CHARNWOOD BOROUGH COUNCIL –CONSERVATION & LANDSCAPE - TREES

APPLICATION NUMBER: P/20/2199/2

LOCATION Land off Leconfield Road, Nanpantan, Loughborough

PROPOSAL Application for Outline planning permission (including point of Access) for up to 30no. dwellings (Class C3) with associated access, landscaping, open space and drainage infrastructure at land off Leconfield Road, Nanpantan.

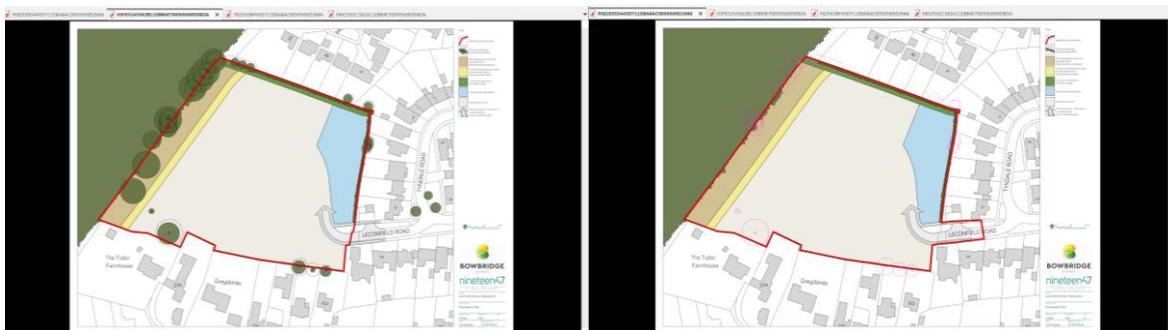
The site lies within the Charnwood Forest area notwithstanding being surrounded on three sides by housing. This elevated and in part steeply sloping site together with its open nature makes an important contribution to the character of the area. Visually the sites upper gradients are prominent affording extensive views across Loughborough to the Wolds.

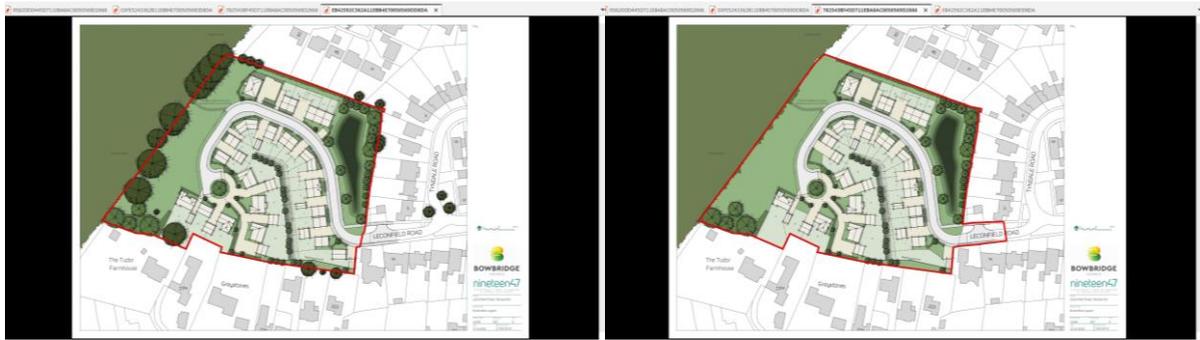
The LUC Landscape Sensitivity Study states that *'development on these slopes may be out of keeping with the existing settlement pattern'*.

Figure 3 Habitat plan in comparison to Tree Survey plan indicates tree on and adjacent to the site

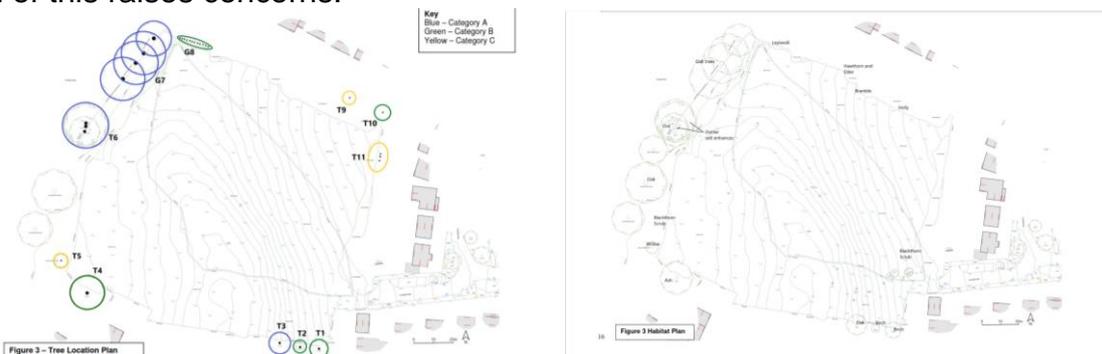
All of this raises concerns.

There is no clear reason why some trees of Burleigh Wood along the perimeter are shown and identified while the ones to the SW are not.
